Project	IEEE 802.16 Broadband Wireless Access Working Group < http://ieee802.org/16 >	
Title	Corrections to STC transmission in OFDM PHY	
Date Submitted	Initial: 2004-11-01	
	Revision 1: 2004-11-12	
	Revision 2: 2004-11-17	
Source(s)	Atul Salvekar Baraa Al-Dabagh Hassan Yaghoobi	mailto:atul.a.salvekar@intel.com mailto:baraa.al.dabagh@intel.com mailto:hassan.yaghoobi@intel.com
	Intel Corporation CHP3-105 350 East Plumeria Dr. San Jose, CA 95134	
	Ambroise Popper SEQUANS Communications	mailto:ambroise@sequans.com
Re:	Supporting document for call for contribution for corrigendum document	
Abstract	In P802.16 REVd/D5 [1], an STC Preamble is only mandatory if there is an STC allocation in the frame. However, in order to get accurate maintenance values, for example power, an additional precursor STC preamble should occur in a preceding frame. In order to alleviate the situation, it is recommended that if there is an STC allocation in frame K and there is no STC allocation in the preceding frame, K-1, then the BS must transmit an STC preamble as the last allocation in the preceding frame, i.e. frame K-1. The issue becomes even more severe in mobile situations where the channel variations

Figure 2: Instability caused by using a single STC preamble for STC data transmission.

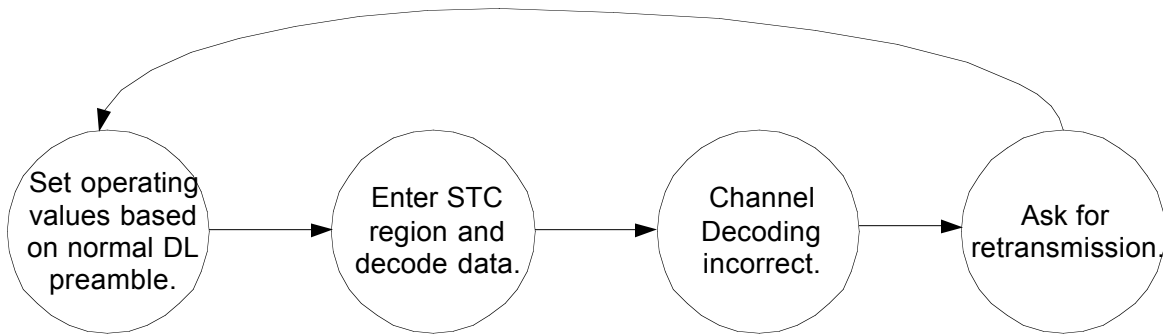
Suppose that during non-STC portions of the frame, the BS transmits on antenna 1. The SS sets operating values based on the DL preamble. Once STC enabled transmission begins, both antenna 1 and antenna 2 transmit, which may make these operating values faulty. This can result in incorrect decoding of the data. For instance the power from a single antenna could be over 20 dB less than that of a second antenna for uncorrelated Rayleigh Fading Channels. In this case, instability can exist as expressed in Figure 1.

Figure 3: New STC Frame structure in TDD

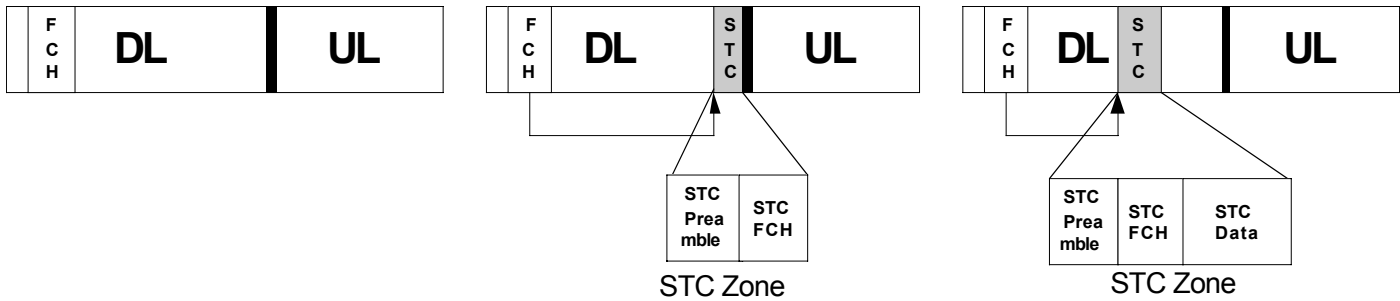
Thus, we suggest that in the case that there is STC encoded traffic in a specific frame, K, without STC encoded data traffic on the previous frame, K-1, the preceding BS DL subframe, K-1, contain an STC zone, in which the STC zone consists of only an STC preamble and ~~with no~~ FCH-STC ~~with no allocation IE~~; DL-MAP and STC data. The SS will be able to determine that there is no STC data allocation in frame K-1 STC Zone by determining that there has been no STC zone in the previous frame K-2. This is expressed in for TDD transmission in Figure 2.

The STC zone starts from a preamble and an STC encoded FCH-STC burst, which is one symbol with the same payload format as specified in Table 239-xxx223. The FCH-STC burst is transmitted at BPSK rate $\frac{1}{2}$. It is followed by one or several STC encoded PHY bursts. The first burst in the STC zone may contain a DL-MAP applicable only to the STC zone. If DL-MAP is present, it shall be the first MAC PDU in the payload of the burst. **The DL map if sent in Burst 1 of the normal frame shall not describe any allocations in the STC region. The STC zone may also contain an UL-MAP, as well as DCD and UCD messages. In the case that there is an STC encoded traffic in a specific frame, K, without STC encoded data traffic on the previous frame, K-1, the preceding DL subframe, K-1, may shall contain an STC zone at the end of the subframe, in which the STC zone consists of only an STC preamble and FCH-STC with no MAP IE, and STC data without FCH-STC, DL-MAP and STC data.** The SS will be able to determine that there is no STC data allocation in frame K-1 STC Zone by determining that there has been no STC zone in the previous frame K-2.

Figure 4: STC FCH

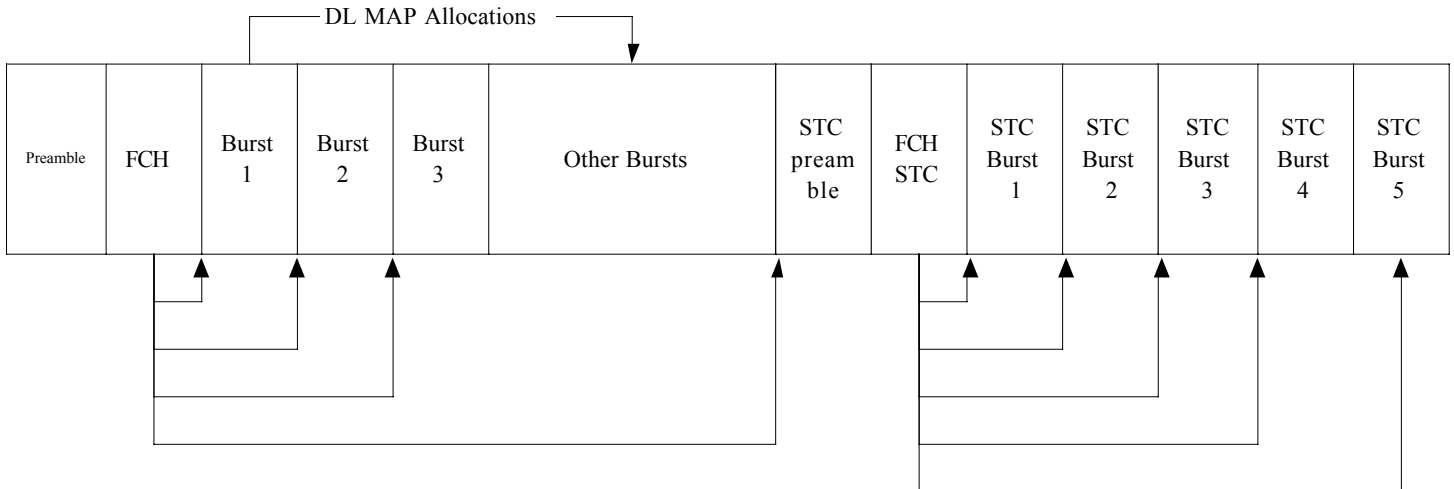
Since a downlink map may be sent in both the normal and STC section of a frame there can be confusion on where should the STC allocation shall be spelled out. Thus we propose that the following be adopted: The FCH STC shall be changed in format to look like the normal FCH DLFP IEs with the restriction that there cannot be another STC region. The following figure illustrates that.

Syntax	Size	Notes
STC_DL_Frame_Prefix_Format() {		
for (n=0; n < 5; n++) {	4 bits	
Rate_ID/DIUC		For all IEs this field is DIUC that defines the burst profile of the corresponding burst.
Preamble-present	1 bit	If '1', preamble is placed before the burst.
Length	11 bits	Number of OFDM symbols in the burst.
}		
HCS	8 bits	An 8-bit Header Check Sequence; calculated as specified in Table 5
